HISTORIC PRESERVATION BOARD STAFF REPORT

310 NE 1st Avenue

Meeting	File No.	Application Type
January 15, 2025	2025-083	Certificate of Appropriateness

The item before the Board is consideration of a Certificate of Appropriateness (2024-083) for an after-the-fact window installation on a contributing single-family structure located at **310 NE 1st Avenue, Old School Square Historic District.**

SLIDING
WINDOW

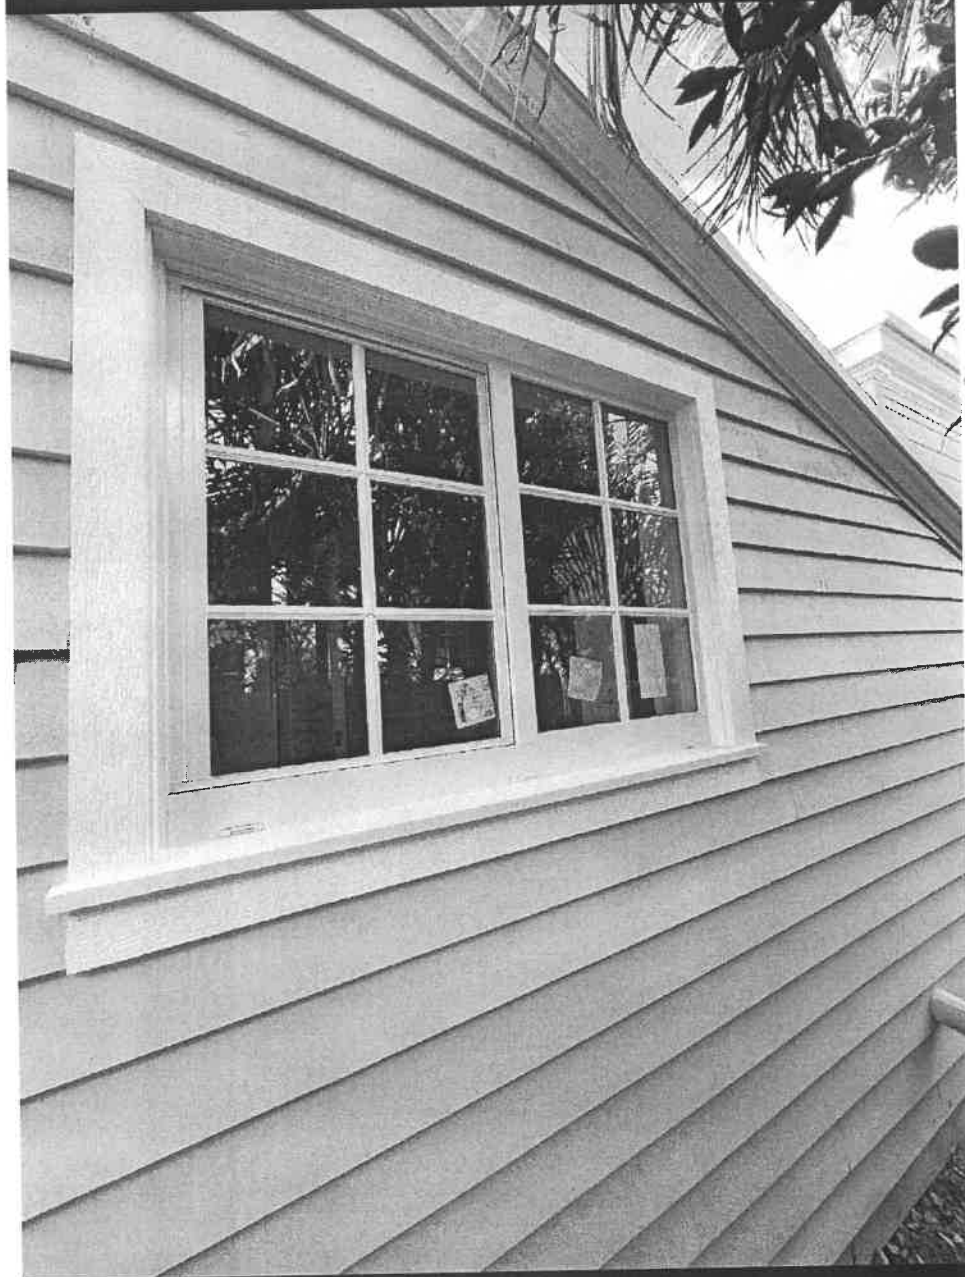
Standard 1, 2, and 5 are applicable. The existing Minimal Traditional structure is currently used as a single-family residence, as it was originally constructed. The subject proposal is for an after-the-fact installation of a horizontal roller window, where a fixed window was approved, on the north side of the structure where the enclosed carport is situated. There is concern with the installed horizontal roller window as this style of window is considered a modern/recent appearance and is not regularly utilized on historic structures within Delray Beach historic districts. Additionally, the approved windows on the existing structure included a combination of fixed and single hung, where the horizontal roller adds a new type of window that was not typical during its time of original construction. Window types and designs are considered a **distinctive feature, finish, construction technique, and example of craftsmanship that helps to characterize the historic property and they shall be preserved.**

The approved elevations also included an 18-lite muntin pattern, where the installed window utilizes a 12-lite pattern. It is noted that the window & door schedule plan sheet indicated a different muntin pattern than the elevation plan sheet within the architectural plan set, a discrepancy that needs to be corrected. The proposed 12-lite muntin pattern can be considered appropriate, however. The appearance of the horizontal roller window resembles the appearance of a fixed window when unused. It is also important to note that the location of the window is on the newly enclosed carport, which now

where horizontal sliders were not used until later in the 20th century. Not only do horizontal rolling windows appear Modern in style they can also appear more commercial in nature. The Visual Compatibility Standards recommended approach for window replacement is **that the relationship of materials, texture, and color of the facade of a building and/or hardscaping shall be visually compatible with the predominant materials used in the historic buildings and structures within the subject historic district.** Further, the Secretary of the Interiors Standards and Guidelines, do not recommend **changing the appearance of windows that contribute to the historic character of the building by replacing materials, finishes, or colors.** Rather, the recommended approach is to utilize materials that match **the old in design, color, texture, and other visual qualities and, where possible, materials.** The installed horizontal roller also impacts the rhythm as all other windows will either be inoperable or open vertically.

There is no concern regarding the proposed frame, as it is white frame aluminum, which can be considered appropriate for this structure. As previously mentioned, the number of panes is proposed to change from the approved 18 to 12. There is not a concern with the appearance of the panes, as they can be considered compatible with the other mullion patterns on the structure. Typically, a request for window replacement is reviewed by staff at the administrative level via the city Building Permit process. However, since the project is under construction and the window has already been installed, the application is before the board for review. The board will need to make a determination that the request is appropriate for the contributing structure and compatible to the Old School Square Historic District.

- The installed sliding window is not visible from the street, or the abutting neighbor's property. There is a 6' wood fence, and approximately 8' hedge, several feet in front of the relevant window.

1. A property will be used as it was historically or be given a new use that requires minimal change to its distinctive materials, features, spaces and spatial relationships. A window was added to the laundry room in order to allow for natural light. It's size, mullions/lites and placement were made considering the appropriateness of same to the scale and design of the original 1940s cottage.

2. The historic character of a property will be retained and preserved. The removal of distinctive materials or alteration of features, spaces and spatial relationships that characterize a property will be avoided. One consideration in adding a window for the new laundry room was that it was not visible from the street, or the abutting neighbor's property.

4. Changes to a property that have acquired historic significance in their own right will be retained and preserved.
5. Distinctive materials, features, finishes and construction techniques or examples of craftsmanship that characterize a property will be preserved. We were careful to pick a scale and use of mullions to create an aesthetic that was consistent with the fenestration of the original cottage.
